BLUE BIRD

R09PB

# Battery Cable Routing **RECALL**

**MODELS AFFECTED:** 2007-2008 BBCV with Caterpillar C7 Engines

PDU pulled outward at right side to gain access to cables at rear of engine

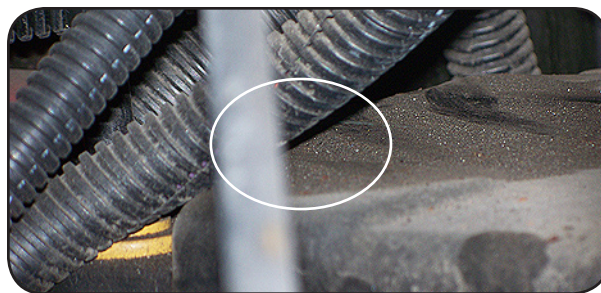
7.2 Locate the two button-head cable ties which secure battery cables to the PDU. If either of the button-head cable ties are broken, missing, or damaged during the removal of the PDU, install new button-head cable ties (0024706) before reinstalling the PDU.

7.3 Inspect the battery cables for any evidence of contact with the rear of the engine, chaffing, or other damage. (Some harnesses may be attached to the engine lifting eye; those are not battery cables.)

- If no damage is evident, and the required 1/2" minimum clearance is provided, proceed to step 8.
- If clearance between the cable(s) and any part of the engine is less than 1/2", perform **Sub Procedure A: Cable Protector Installation**.

Area of possible cable damage against front edge of transmission cover plate

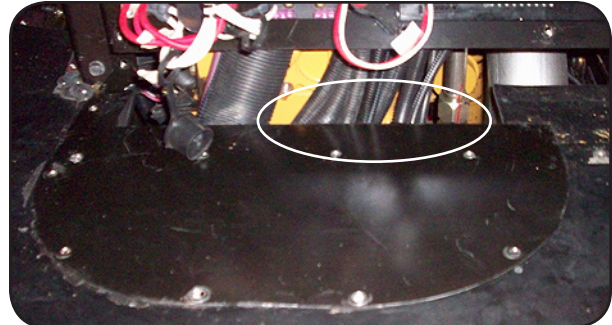
7.4 Inspect all the harnesses passing under the front edge of the transmission cover, as follows:

- If no contact between the transmission cover and harnesses is evident, proceed to step 8.
- If any evidence is found of chaffing or other damage due to contact against the transmission cover, perform **Sub Procedure B: Relocate Transmission Cover**.

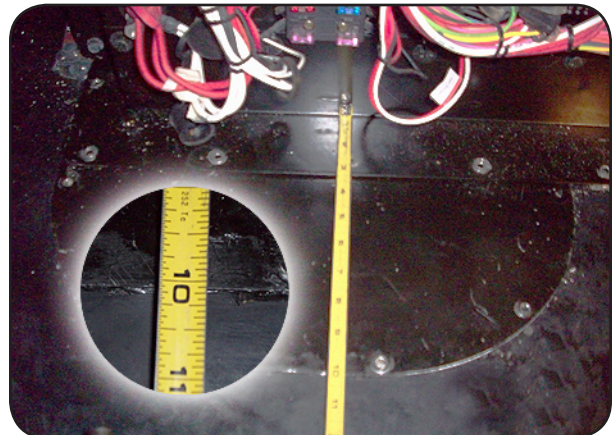
**1** If any evidence of cable loom contact with the engine, chafing, or other damage is evident, or if clearance between the battery cable(s) and any part of the engine is less than the required minimum ½" but cannot be repositioned, inspect further to determine the extent of damage:

- If the loom has been rubbed, but no damage to the battery cable inside has occurred, then install cable protector (BB # 0040818) between the engine and battery cable. Wrap the protector around the cable loom and secure it with two Cable Ties (BB # 0029999) as shown below.
